Product Change Notification / ALAN-11ELYX284

CCB 4768 Final Notice: Qualification of ANAP as an additional assembly site for selected Atmel ATSAMG55J19A and ATSAMG55J19B device families available in 64L LQFP (10x10x1.4mm) package.

Pre and Post Change Summary

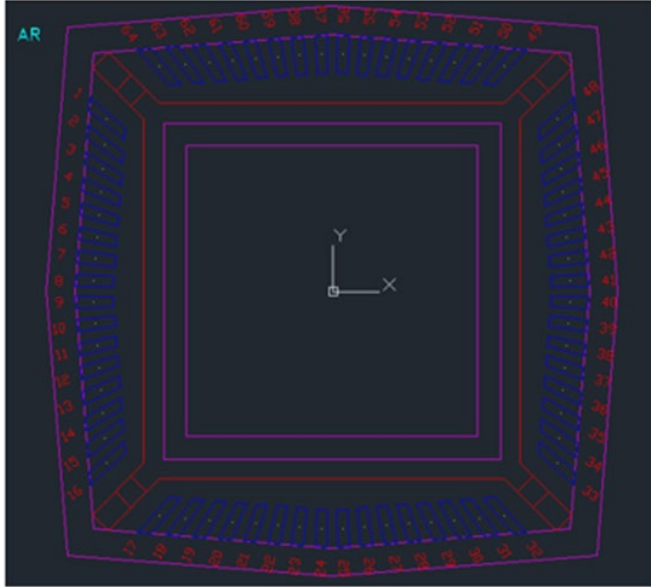
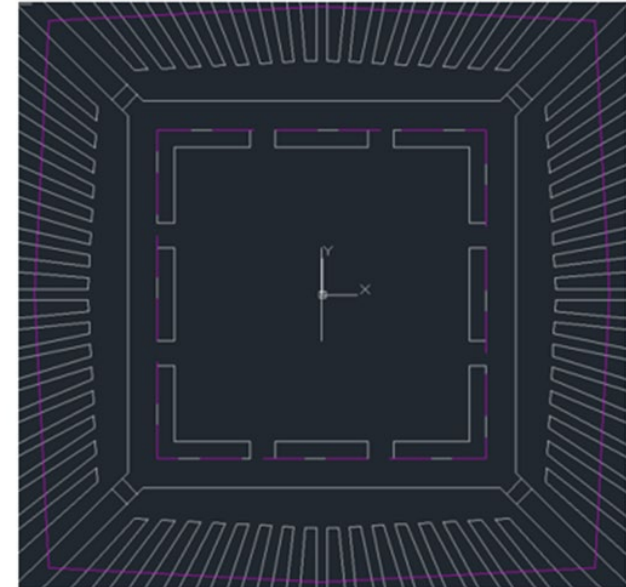
Assembly location	ASE Inc. (ASE)
Lead frame material	C7025
Lead frame paddle size	200x200 mils

Assembly location	Amkor Technology Philippine (P1/P2), INC. (ANAP)
Lead frame material	C194
Lead frame paddle size	138x138 mils
